**TOWN OF NEWBURGH
PLANNING BOARD
TECHNICAL REVIEW COMMENTS**

PROJECT NAME: HADID CLEARING & GRADING APPLICATION-34 SUSAN DR
PROJECT NO.: 2021-10
PROJECT LOCATION: SECTION 46, BLOCK 5, LOT 21
REVIEW DATE: 26 AUGUST 2021
MEETING DATE: 2 SEPTEMBER 2021
PROJECT REPRESENTATIVE: ENGINEERING & SURVEYING PROPERTIES

**RE: W.O. # 1592.01
PB APPLICATION 2021-10
HADID
34 SUSAN DRIVE
COMMENT RESPONSE**

SANITARY SEWER DISPOSAL SYSTEM PROFILE

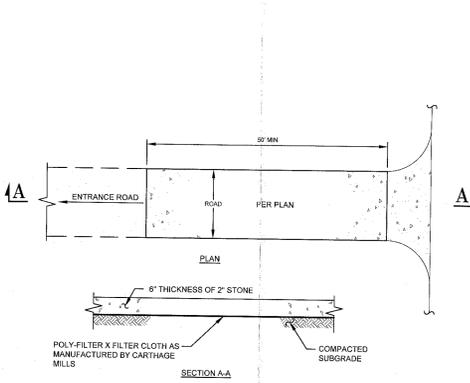
4. The Applicants representatives have redesigned the proposed grey water line between the septic tank and the new proposed leech field. Energy dissipation has been considered in the design with the addition of a distribution box with baffle prior to the leeching fields.

Depth of the proposed sanitary sewer pipe has been revised. Additionally, a manhole box with a baffle is proposed at the toe of the steep slope to slow the flow of effluent prior to entering the septic field.
